Date: November 4, 2019
To: Beth Callahan, Project Manager, Maine Department of Environmental Protection
Karem Gungor, Environmental Engineer, Maine Department of Environmental Protection
From: Elizabeth M. Ransom, P.G. Ransom Consulting, Inc.
Subject: Nordic Aquafarms, Inc., Land-based Aquaculture Facility, Belfast, Maine
L-28319-26-A-N, Review Comments

This memo provides responses to the Technical Review Memorandum from Karem Gungor to Beth Callahan dated October 3, 2019. For clarity, the entire comment from the technical memorandum has been copied below and italicized. Responses are in regular text, and on the attached plans and figures as referenced below.

CE117

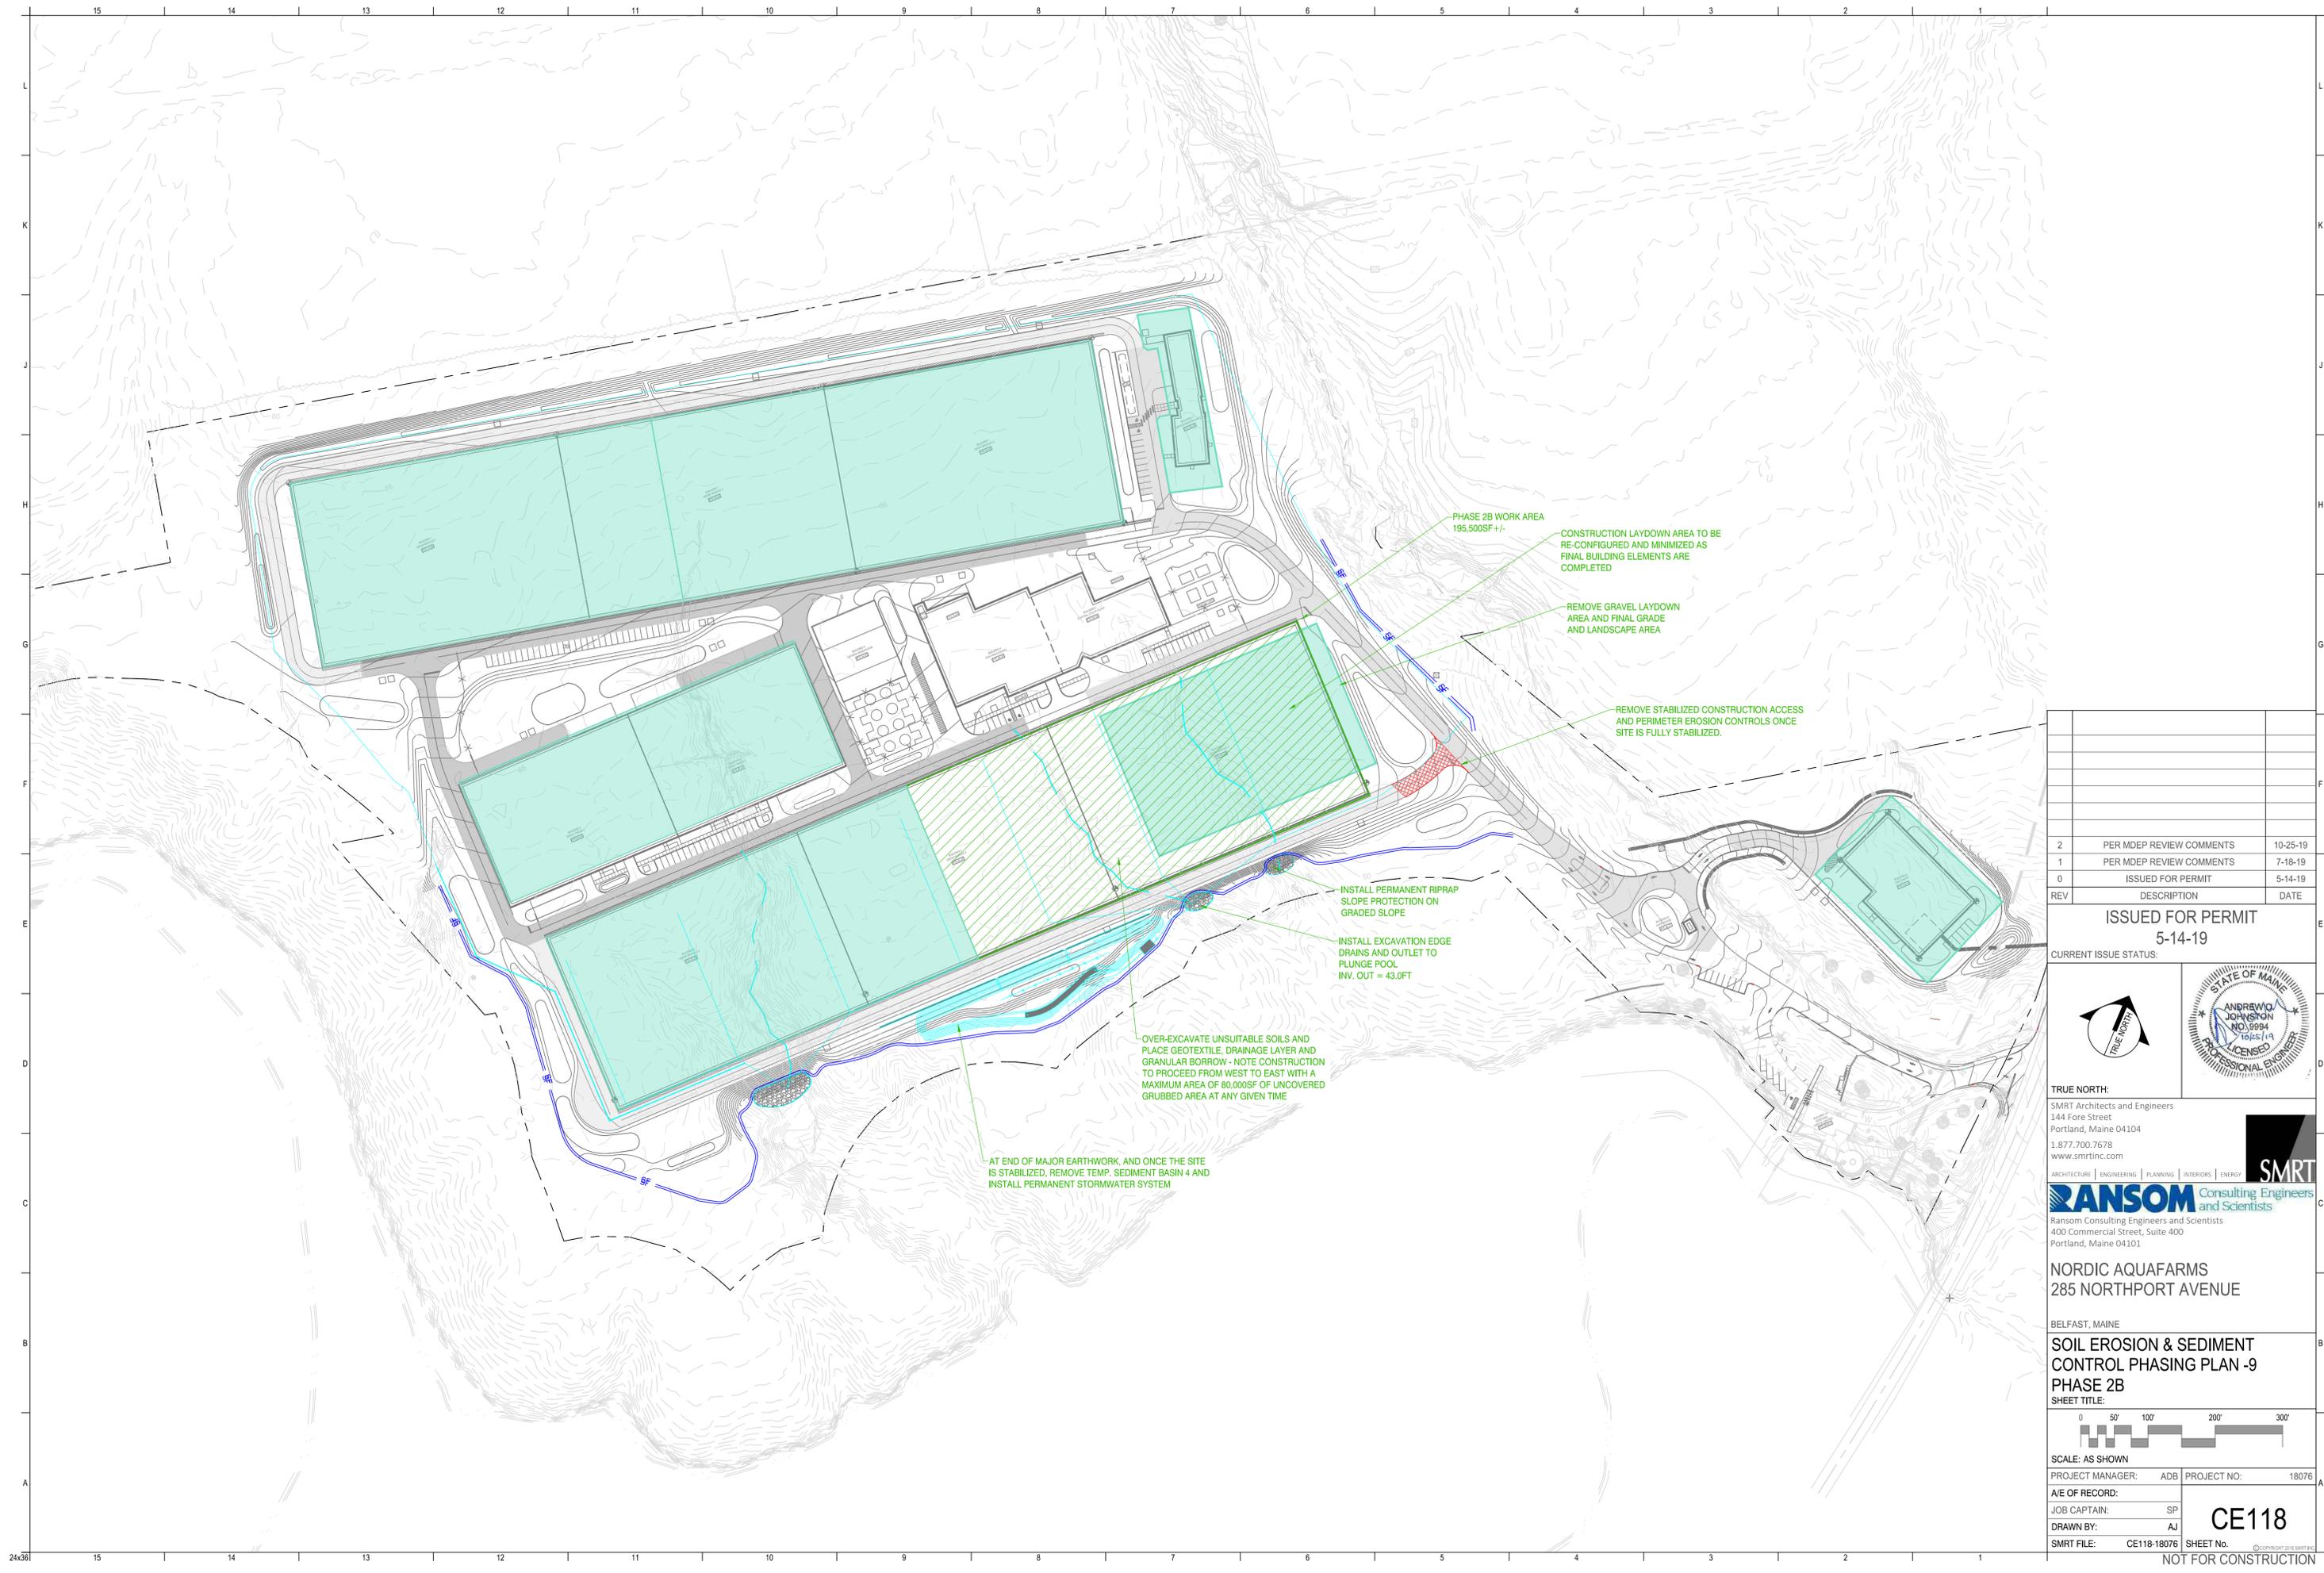
b. Eliminate the westerly and easterly outfalls of the trench underdrain shown in Sheet CE111. The outfalls may be necessary during the initial phases of the project; but they need to be removed or

deactivated post construction to simulate the pre-development site hydrology to the extent practicable and mitigating the project's hydrologic impact on the jurisdictional streams,

1b. Elimination of the Phase 1 outlets is shown during Phase 2A of the project and noted on revised sheet CE117.
